Flight Procedures Cover Page	Task Action: FLIGHT CHECK	Task Type: IAP	Estimated Chart Date: 03/19/2026	APWS Task ID: 9B1810907AFD448D99D6F3563DC28138	APWS Project ID: 38C4D3376A724C3987525CC2789303D7
Procedure: ILS OR LOC RWY 35L AMDT 6		Enroute: NO	Specialist: Purnell, Troy		Agreement Number:
Airport ID: KDEN			Airport City: DENVER		State: CO
Facility ID:	Facility Type:	Flight Inspection Remark Type: New FC Slot

**Procedure Comments:**  
AMEND MISSED APPROACH. REMOVE REFERENCES TO DEN VOR FOR FUTURE DEN VOR DECOM. AFS REQUIRED.

Denver, CO  
Denver International, KDEN  
ILS OR LOC RWY 35L

# ILS or LOC RWY 35L

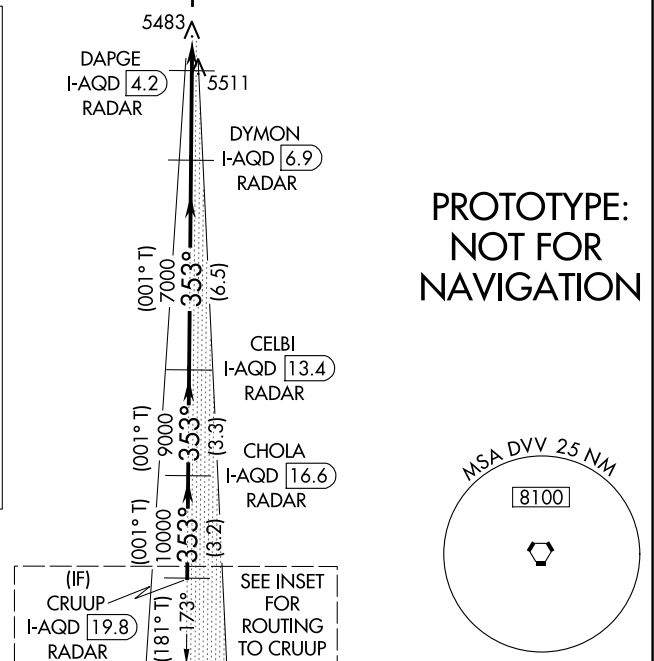
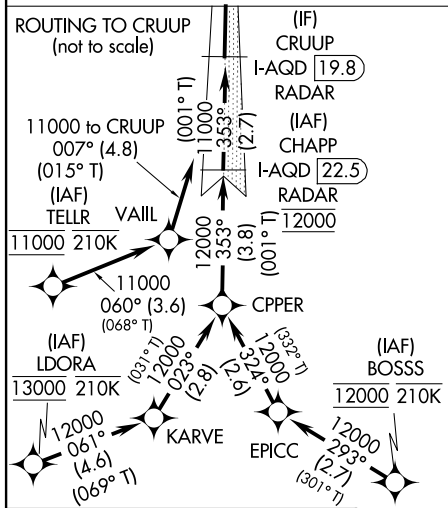
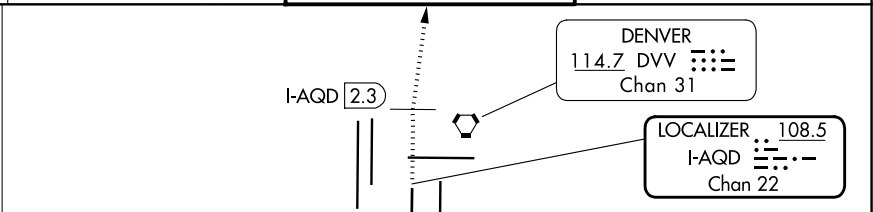
1. CHANGED MISSED APPROACH INSTRUCTION FROM "CLIMB TO 10000 ON HEADING 353 TO I-AQD 2.29 DME BEFORE TURNING DIRECT GLL VOR/DME AND HOLD" TO "CLIMB TO 10000 ON HEADING 353 TO I-AQD 2.29 DME NORTH OF I-AQD AND DIRECT GLL VOR/DME AND HOLD."
2. CHANGED LOC MAP FROM "4.75 NM AFTER DYMON/I-AQD 6.90 DME/RADAR OR AT I-AQD /2.15 DME" TO "4.75 NM AFTER DYMON/I-AQD 6.90 DME/RADAR OR AT I-AQD 2.15 DME".

MISSED APPROACH: Climb to 10000 on heading 353° to I-AQD 2.3 DME before turning direct GLL VOR/DME and hold.

# ILS RWY 35L (CAT II & III)

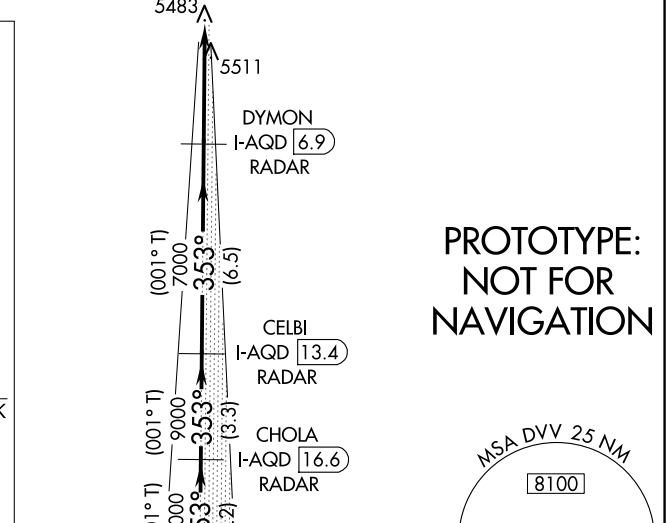
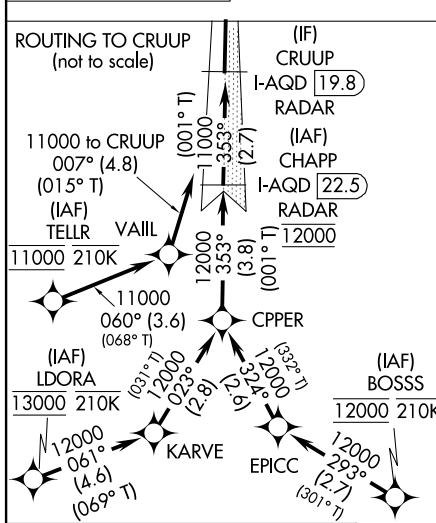
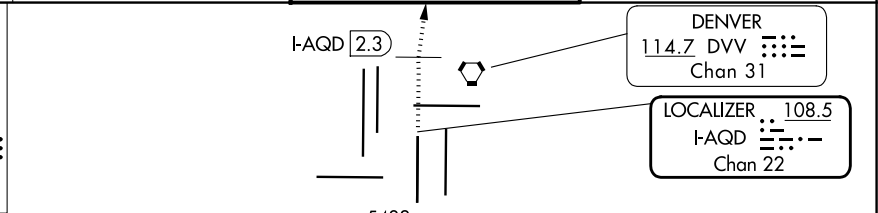
ALSIF-2  
MISSED APPROACH: Climb to 10000 on heading 353° to I-AQD 2.3 DME before turning direct GLL VOR/DME and hold.

# ILS RWY 35L (SA CAT I)

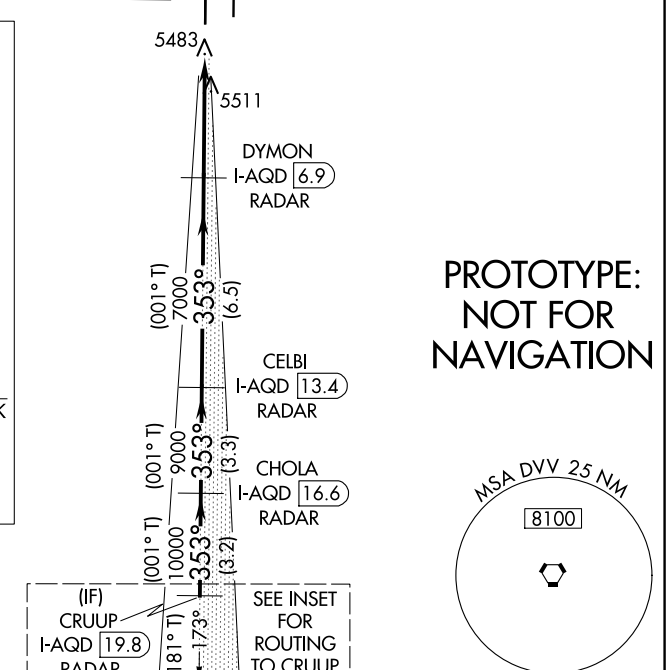
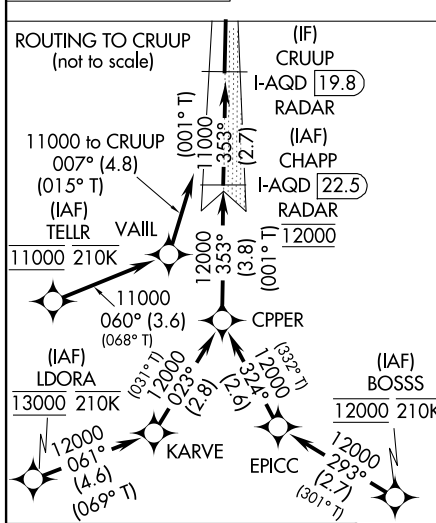
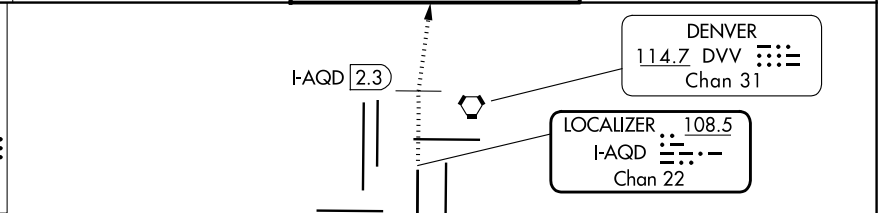
MISSED APPROACH: Climb to 10000 on heading 353° to I-AQD 2.3 DME before turning direct GLL VOR/DME and hold.
